From: Franzone, Steve [<mailto:Steve.Franzone@fpl.com>]
Sent: Monday, September 24, 2012 2:33 PM
To: Comar, Manny
Cc: Franzone, Steve; Maher, William; Burski, Raymond
Subject: DRAFT RAI Responses FPL Turkey Point 6 & 7 for eRAI 5896 Basic Geologic and Seismic Information

NRC RAI Letter No. PTN-RAI-LTR-037

NRC RAI Number: 02.05.02-3 (eRAI 5896)

NRC RAI Number: 02.05.02-5 (eRAI 5896)

New Caribbean Model Geometry

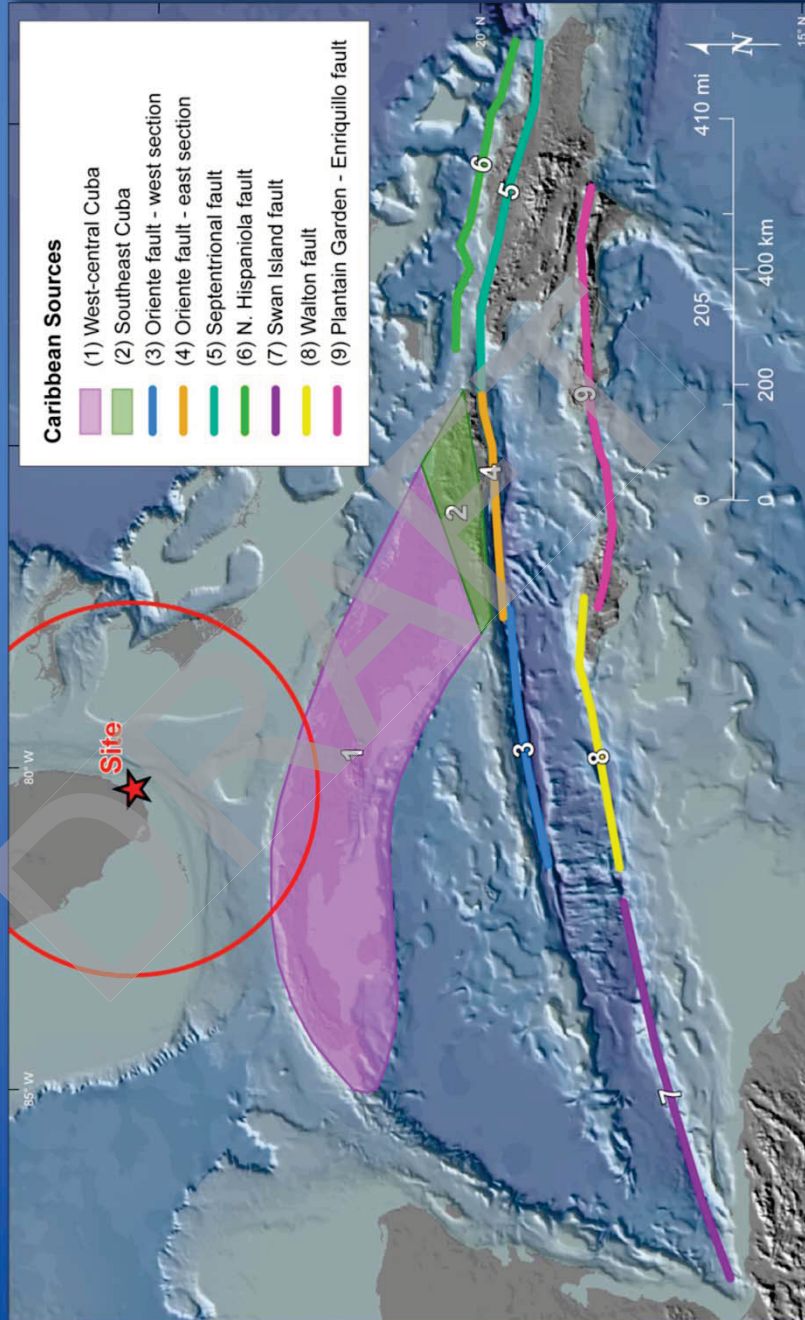
FSAR Subsection 2.5.2.4.4.3.1 describes summary information related to the SSHAC Level 2 study on new seismic source models for the Cuba and northern Caribbean region,. In accordance with NUREG-0800, Standard Review Plan, Chapter 2.5.2, "Vibratory Ground Motion", and Regulatory Guide (RG) 1.208, "A Performance-Based Approach to Define the Site-Specific Earthquake Ground Motion," please provide the complete SSHAC documentation detailing specifically:

- a. Procedures and any assumptions made in developing the Caribbean seismic sources,
- b. The questionnaire used in obtaining expert opinions,
- c. The TI any advisory groups and/or peer reviewers used,
- d. How the experts' opinions were integrated into the development of the final models. Discuss expert opinions and/or suggestions that were left out of the final model and justifications for doing so,
- e. How conflicting opinions among the experts were dealt with,
- f. How the final models represent the consensus of the informed community

As a preliminary "straw man" model, we have identified the following six seismic sources in the northern Caribbean region as relevant to seismic hazard in southern Florida (see attached figure):

- (1) West-central Cuba (area source)
- (2) Southeastern Cuba (area source)
- (3) Oriente fault zone west, between Cuba and the Cayman spreading center
- (4) Oriente fault zone east, directly south of Cuba
- (5) Septentrional fault, between the northern Dominican Republic and eastern Cuba
- (6) North Hispaniola thrust fault, north of the Dominican Republic
- (7) Swan Island fault zone, west of the Cayman spreading center
- (8) Walton fault zone, between Jamaica and the Cayman spreading center
- (9) Plantain Garden-Enriquillo fault zone, between southern Dominican Republic and Jamaica

It is our assessment that faults in Cuba are not sufficiently characterized to warrant fault (line) sources. The source zone boundaries for Cuba are defined by tectonic landforms, geology, and seismicity (see figure).

Figure 1. Comparison of converted magnitudes for the complete modified Phase 2 catalog: FSAR vs. CEUS SSC (EPRI et al., 2012). This figure represents the M_w correlation among 10,747 events.

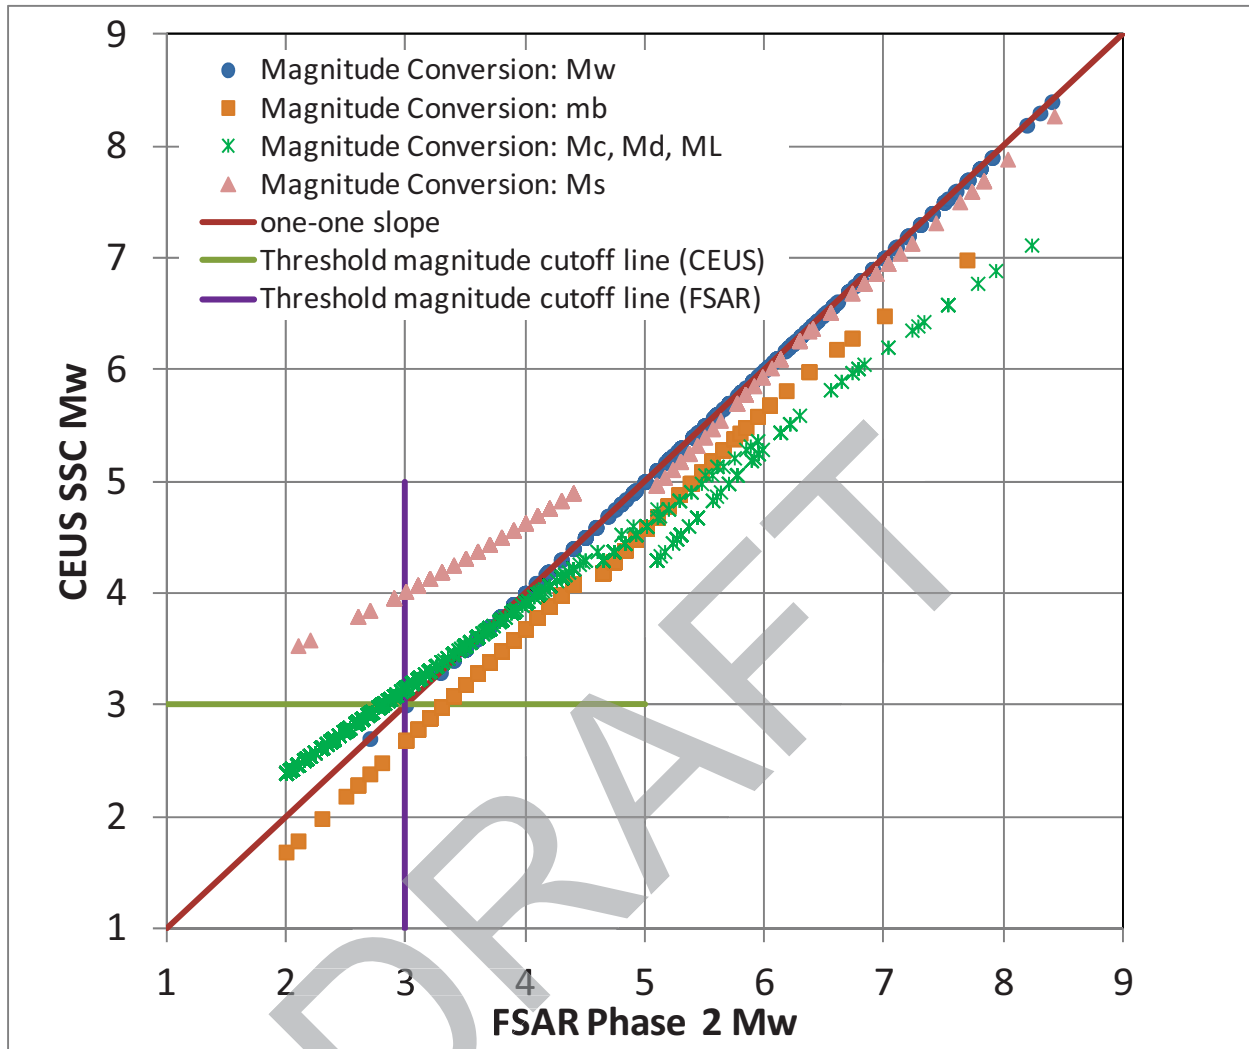
FSAR Subsection 2.5.2.1.3.1 states that M_w was used as the uniform magnitude measure in Phase II (Caribbean region) earthquake catalog development efforts. Phase I earthquake catalog (EPRI updates), on the other hand, uses m_b as the uniform magnitude measure. In accordance with NUREG-0800, Standard Review Plan, Chapter 2.5.2, "Vibratory Ground Motion," and Regulatory Guide (RG) 1.208, "A Performance-Based Approach to Define the Site-Specific Earthquake Ground Motion", please explain the rationale for selecting M_w as the uniform magnitude measure for the Caribbean earthquake catalog rather than m_b . Discuss what impact, if any, this choice had on the number of earthquakes listed in the Caribbean earthquake catalog. Were there any earthquakes with m_b of 3.0 (or perhaps larger) that did not make the $M_w \geq 3.0$ cut used in Phase II catalog development?

leads to a smaller estimate of moment magnitude than considered in the FSAR – see Figure 1. For example, if the CEUS-SSC magnitude conversion relations had been considered for the Phase 2 catalog, the moment magnitude equivalent to m_b 3.0 would be about M_w 2.7, instead of the M_w 3.0 in the FSAR.

Figure 1 indicates that for about M_w 3.5 and greater, the CEUS SSC leads to smaller converted M_w magnitudes, notably so for the largest magnitudes. For M_w less than about 3.5 the CEUS SSC magnitude conversions lead to slightly larger M_w magnitudes. Further, considering the intent of presenting the Phase 2 catalog as M_w 3.0 and greater, the CEUS SSC magnitude conversions would add some additional events which the FSAR catalog would have considered M_w 2.8 to 3.0.

leads to very similar estimates of moment magnitude for earthquakes larger than 4.5 as those that were considered in the FSAR (FSAR 2.5.2) – see Figure 1. For the relatively few events with M_s less than 4.5 in the Phase 2 catalog, the CEUS SSC magnitude conversion leads to larger M_w magnitudes than the conversion assumption of equivalence in the FSAR.

The impact on the number of Phase 2 catalog earthquakes of M_w 3.0 and greater, considering the CEUS SSC magnitude scale conversion relations in lieu of the relations used in the FSAR, is summarized in Table 2. The number of M_w 3.0 and greater events would increase from 8747 to 9212 when using the CEUS SSC relations. The number of M_w 5.0 and greater would decrease from 787 events to 552 events. Figure 1 graphically presents the related conclusion, that considering the CEUS SSC magnitude scale conversion relations, there would be an increase in the number of smallest magnitude events, while there would be an equivalence or decrease in magnitude for all events of FSAR M_w 4.5 and greater.
